FINAL ENVIRONMENTAL IMPACT REPORT

Figueroa Streetscape Project

ENV 2012-1470-EIR

FIGUEROA STREETSCAPE PROJECT FINAL ENVIRONMENTAL IMPACT REPORT

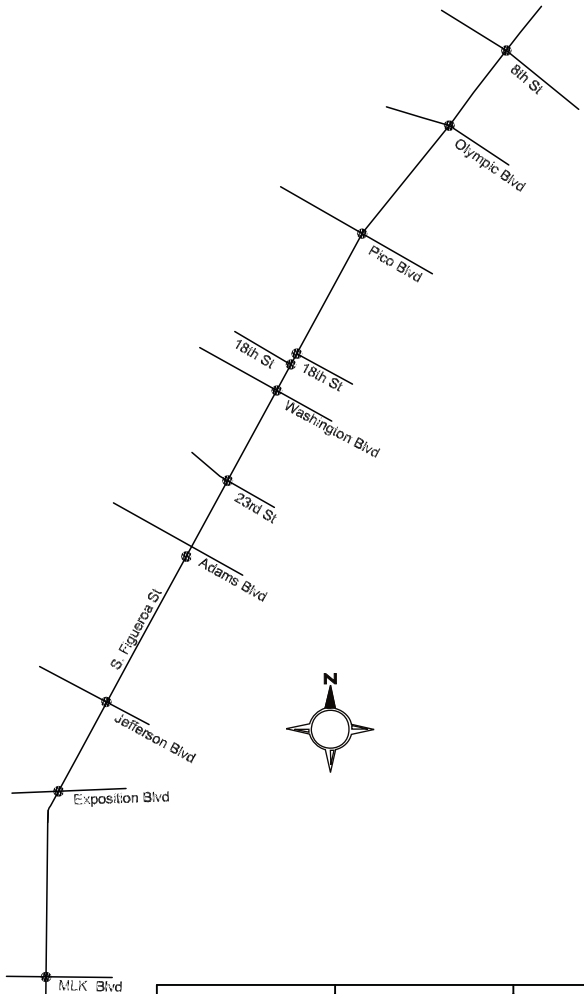
- Page 3-21 (Figure 3-12), Project Description, Labeling of Figures. Figure 3-12, (S. Figueroa Street) has been revised to show the new configuration and to clarify the labeling of project alternatives. In the Draft EIR, they show lane configurations as “Alternative 1” and “Alternative 2”. In the following what is labeled as Alternative 1 is EIR Alternative 2A, and what is labeled as Alternative 2 is Alternative 2B:

Between Venice Boulevard and 8th Street, one northbound mixed-flow travel lane would be eliminated. From Venice Boulevard to Olympic Boulevard, there will be two full time mixed-flow travel lanes in the southbound direction and two full-time mixed-flow travel lanes one peak-period bus-only lane (mixed-flow off-peak) in the northbound direction, and a center left-turn lane. Buffered bicycle lanes are currently proposed between 21st Street and 11th Street in each direction. Ten off-peak period parking spaces would be eliminated from Venice Boulevard to Pico Boulevard on the east side of the street.

From Olympic Boulevard to 9th Street there will be a two full-time north-bound mixed-flow travel lanes and a peak-period bus-only lane, and a between 8th Street and 9th Street an additional peak-period mixed-flow lane on the west side of the roadway, which becomes a full time lane just north of 8th Street. A cycle track is proposed from 11th to 7th Street in the northbound direction only. 28 parking spaces would be eliminated on both side of the street between 8th Street and 7th Street.
